**CITY OF BOULDER**  
**PLANNING BOARD MEETING AGENDA**  
**DATE:** August 18, 2016  
**TIME:** 6 p.m.  
**PLACE:** 1777 Broadway, Council Chambers

**AGENDA TITLE:** CONCEPT PLAN & REVIEW - Redevelopment of the existing seven-acre apartment site located at 1550 Eisenhower Drive with a new three-story apartment complex Eastpointe Apartment Homes, consisting of 236 proposed units in five buildings with below grade parking and on-site recreational amenities under case review no. LUR2016-00043.

**SUMMARY:** CONCEPT PLAN & REVIEW – Proposal for five new three-story apartment buildings, a fitness building and associated site amenities with below grade parking. A total of 236 apartment units are proposed where 140 units exist today.

Figure 9: Urban Design Suggestions to Applicant regarding Concept Plan

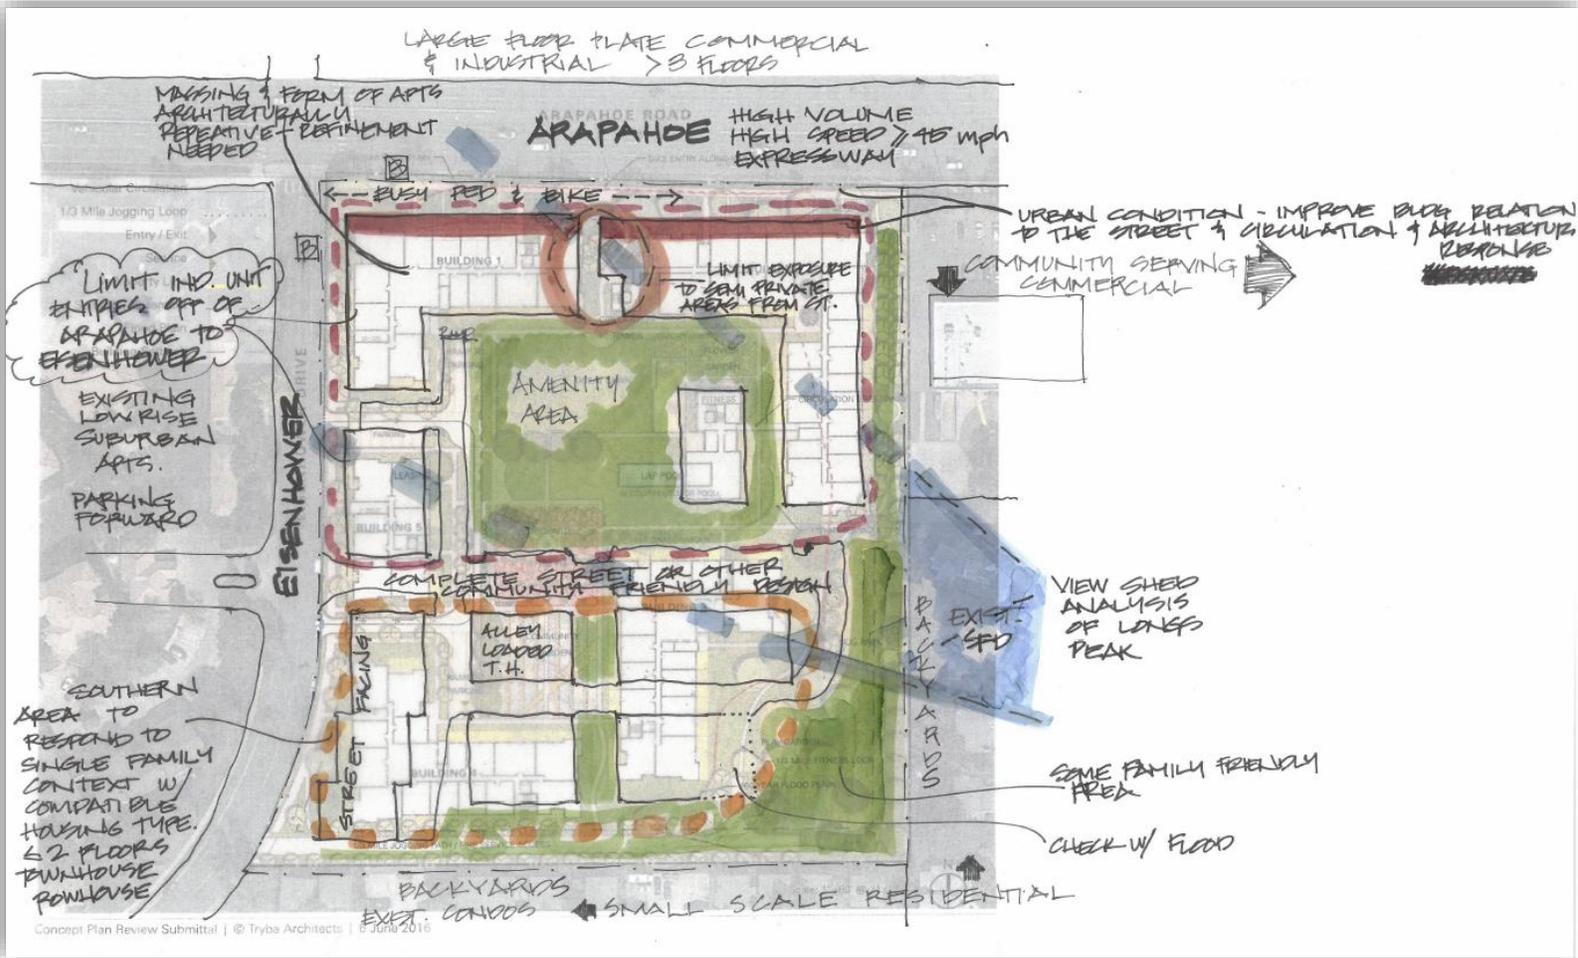
Recognizing the high density land use and zoning on the site and the typology of Arapahoe Avenue, the northern portion of the site can accommodate bigger buildings and a greater degree of intensity however, the proposed site plan should consider the existing surrounding residential uses that are smaller in scale and stature, particularly the single family detached homes to the south. The Site Plan should consider the following to better address the context and surroundings, and as shown in the graphic on the following page in **Figure 9**:

- Break up the superblock by creating a distinct transition to a less massive building type and units on the south side of the site, with the transition being a complete street as shown in **Figure 9**.
- Improve the building’s relationship to the street, and circulation and architectural response as the buildings could create more of an urban edge to the broad right-of-way of Arapahoe Avenue, rather than be setback by approximately 50 feet as shown on the Concept Plan, with private yard space along Arapahoe Avenue.
- Limit individual unit entries off of Arapahoe Avenue, given the high volume arterial, and instead provide for overall building entries off Arapahoe and individual unit entries off of Eisenhower.

**Figure 11: Exterior Material Proposal**

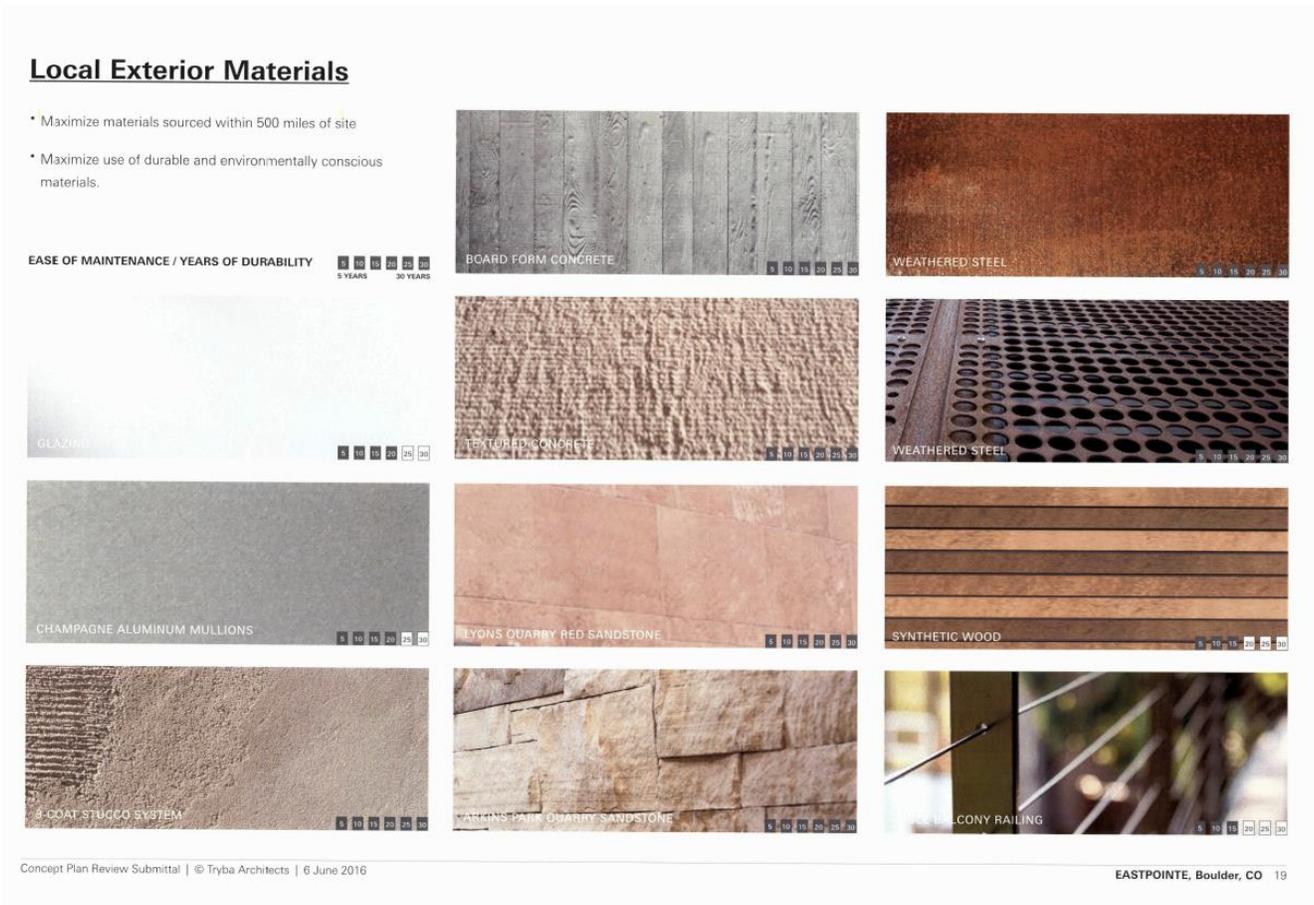
- As discussed with the applicant in a review of the comments, staff and the applicant concurred that some edges or portions of buildings should be converted to two-story massing. Similarly, while the early proposal for exterior materials (shown in **Figure 11**) does appear to be durable and of high-quality, staff recommends reconfiguring the finish materials distinctly on different buildings, such that the buildings don't appear as a duplications of one another.
- The building typology on the south end of the site should consider more of a townhome configuration to transition to the adjacent single family residential and smaller apartment buildings.
- Setback units from southeast property line and perform a viewshed analysis from adjacent neighborhood to preserve view corridors to the northwest.

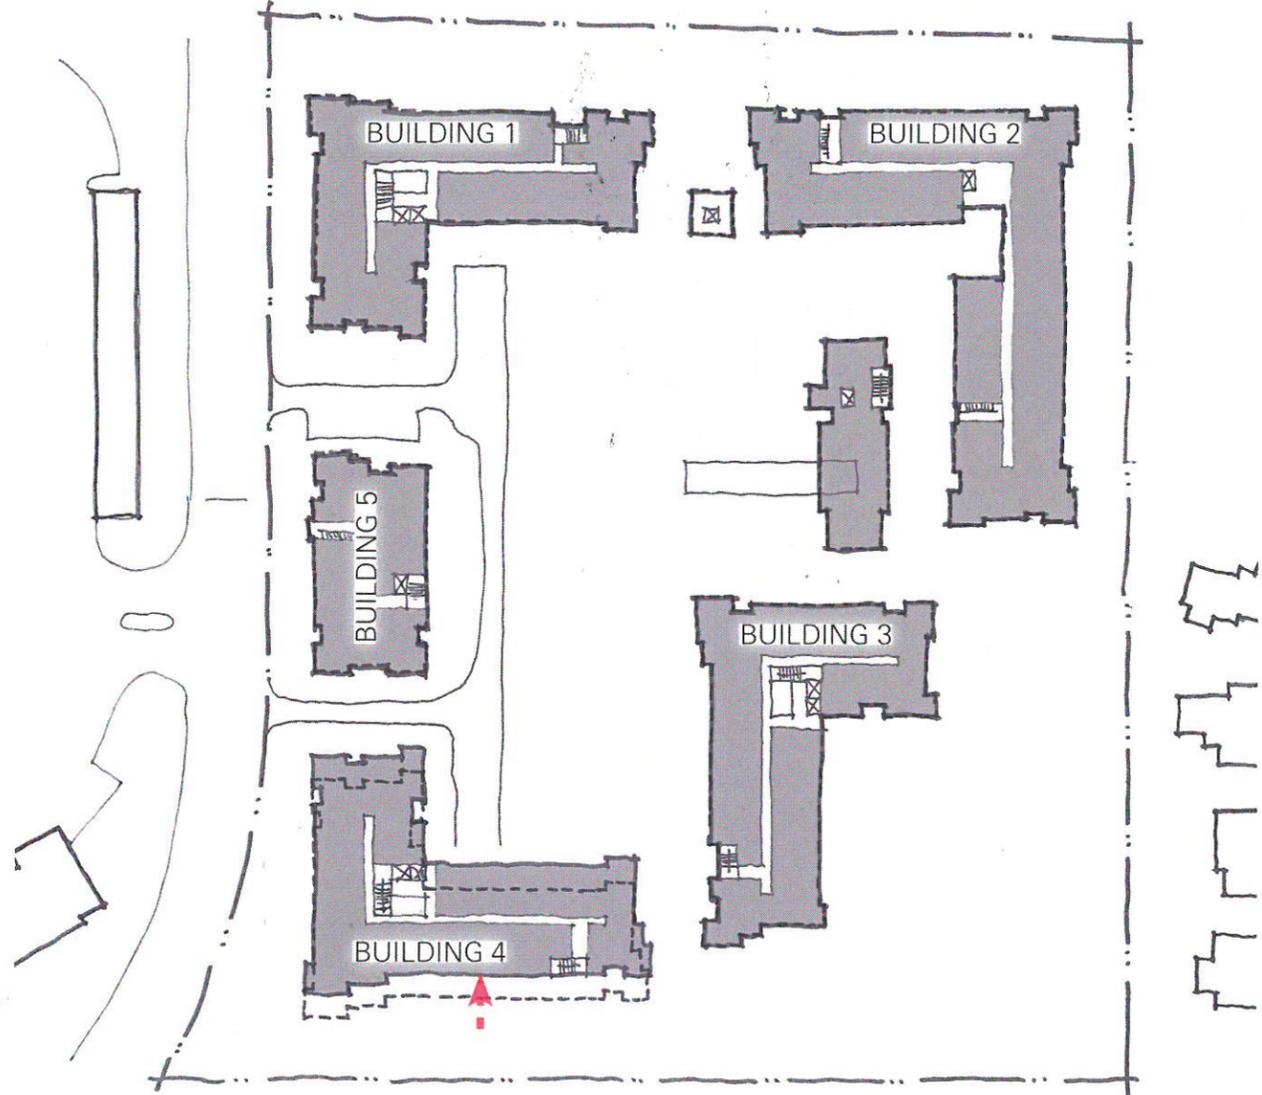
MOVE BUILDING 4 NORTH 12 FEET

## INTEGRATE SINGLE ACCESS POINT

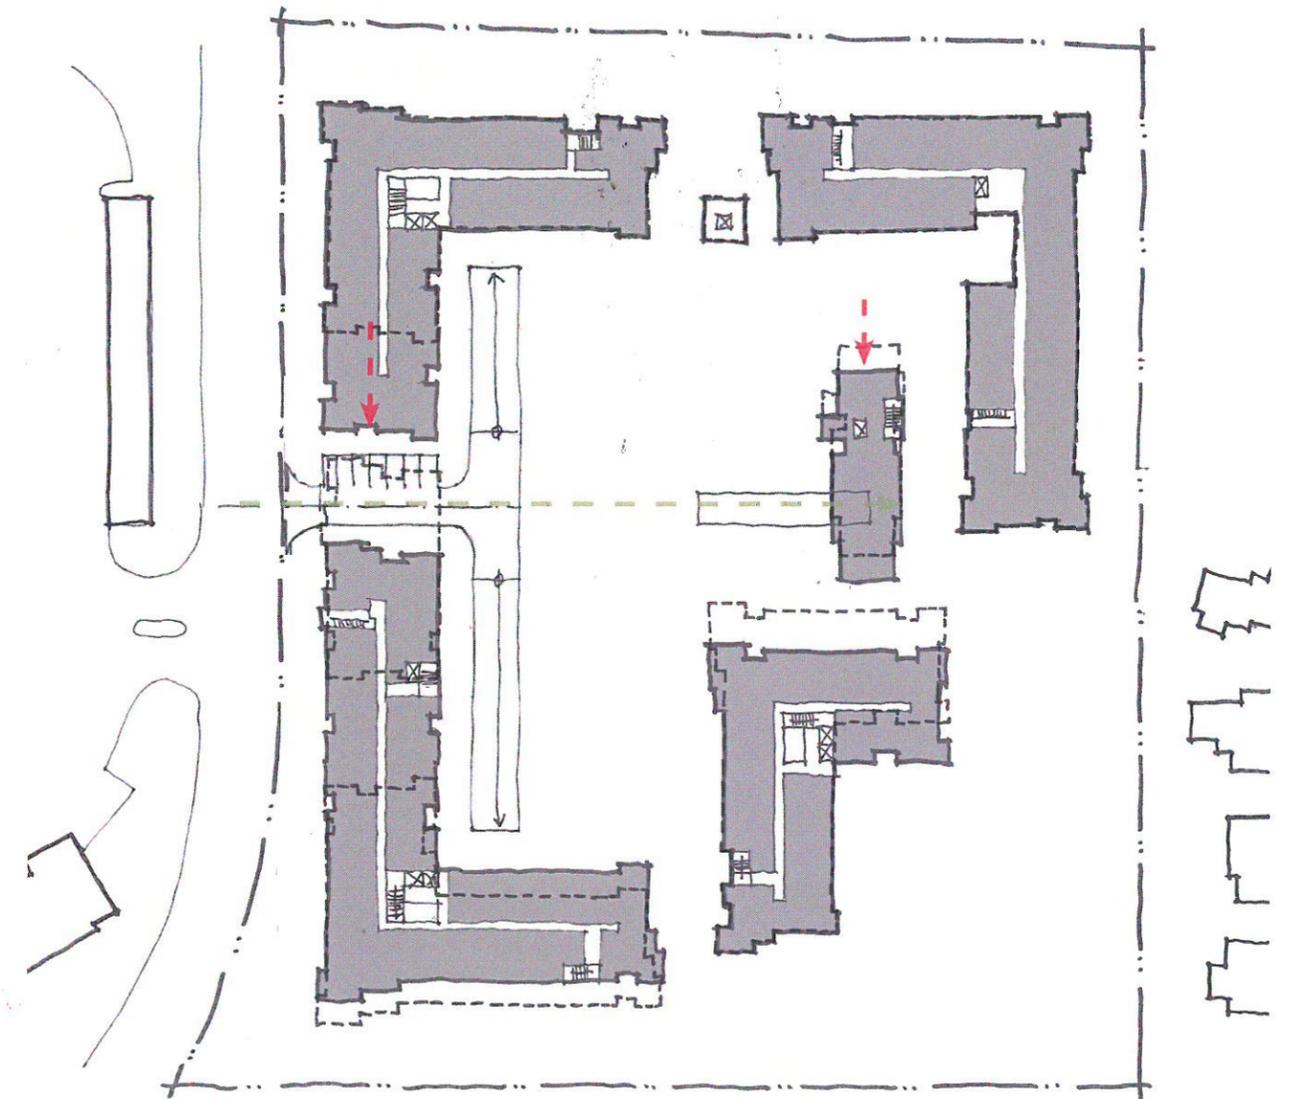
- MERGE BUILDINGS 4 AND 5 TO ALLOW FOR SINGLE ACCESS POINT
